Access Compliance Report

Public Rights-of-Way

(Curb Ramps)

Intersection ID: 2827	Main Street: DERVISH_LN	Cross Street: SWALLOW_TAIL_LN	Location: S
ADA ID: 3A2BCD1578DF	Ramp Type: PerpDiag	Initial Pass/Fail: Fail	Overall Compliance: No
			Severity Score: 21.25

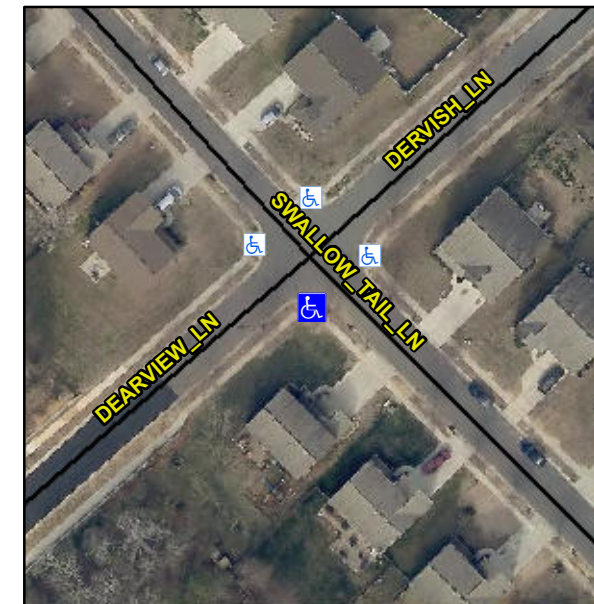
Not Found, R304.5.1, R304.5.3

Compliance	Description	Data	Compliance	Description	Data
N/A	Ramp Length (in)	48.0	Yes	Ramp Slope (%)	6.4
No	Ramp Width (in)	36.0	No	Ramp XSlope (%)	5.3
N/A	Flare Type LT	N/A	N/A	Flare Type RT	N/A
N/A	Flare Slope LT (%)	N/A	N/A	Flare Slope RT (%)	N/A
N/A	Flare Traversable LT?	N/A	N/A	Flare Traversable RT?	N/A
N/A	Landing Length (in)	N/A	N/A	DWS Provided?	N/A
N/A	Landing Width (in)	N/A	N/A	DWS Contrast?	N/A
N/A	Landing Slope (%)	N/A	N/A	DWS Length (in)	N/A
N/A	Landing X Slope (%)	N/A	N/A	DWS Full Width?	N/A
N/A	Landing Curb? (Y/N)	N/A	N/A	DWS Offset (in)	N/A
N/A	Shared Landing?	N/A			
N/A	Gutter Ponding?	N/A	N/A	Gutter Slope (%)	N/A
N/A	Gutter Lip Ht (in)	N/A	N/A	Gutter X Slope (%)	N/A
N/A	Painted X Walk1?	No	N/A	Painted X Walk2?	No
	X Walk 1 Direction	To NE		X Walk 2 Direction	To NW
N/A	X Walk 1 Width (in)	N/A	N/A	X Walk 2 Width (in)	N/A
	X Walk 1 Slope (%)	0.7		X Walk 2 Slope (%)	1.8
	X Walk 1 X Slope (%)	1.9		X Walk 2 X Slope (%)	2.6

Remove & Replace Curb Ramp With Two New Directional Ramps or Equivalent.
